AMENDMENT TO THE DRAWINGS

REMARKS

FIG 3

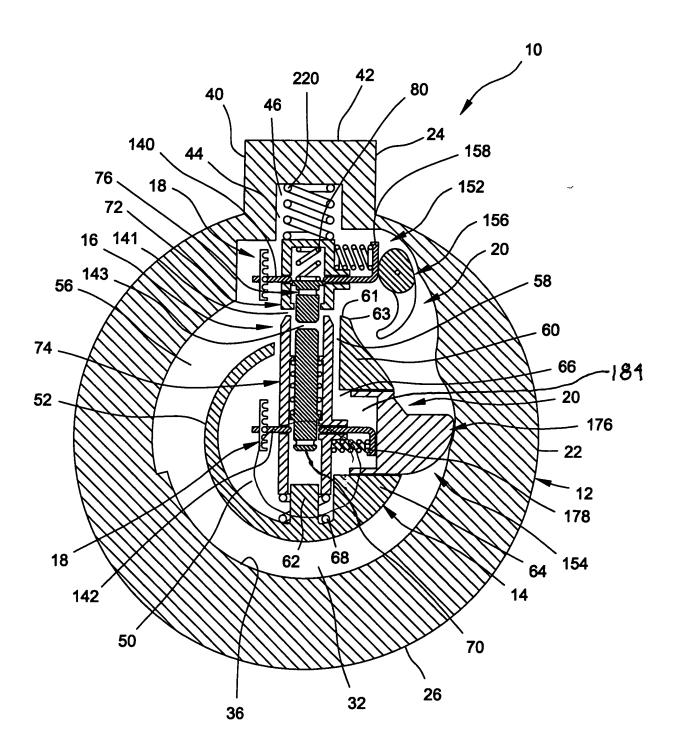
Applicant submits herewith a copy of Figure 3 with proposed amendments in red.

The numeral 70 is redirected to indicate the correct surface. Applicant also submits a replacement sheet incorporating the proposed amendments.

The third informality questions how surface 216 can contact surface 70 as seen in Figure 3, yet allow the key to engage the bottom of the pins as seen in Figure 2. Figure 3 is being amended to redirect the leader line from numeral 70, thereby obviating the objection, and Applicant respectfully requests withdrawal of the related objection.
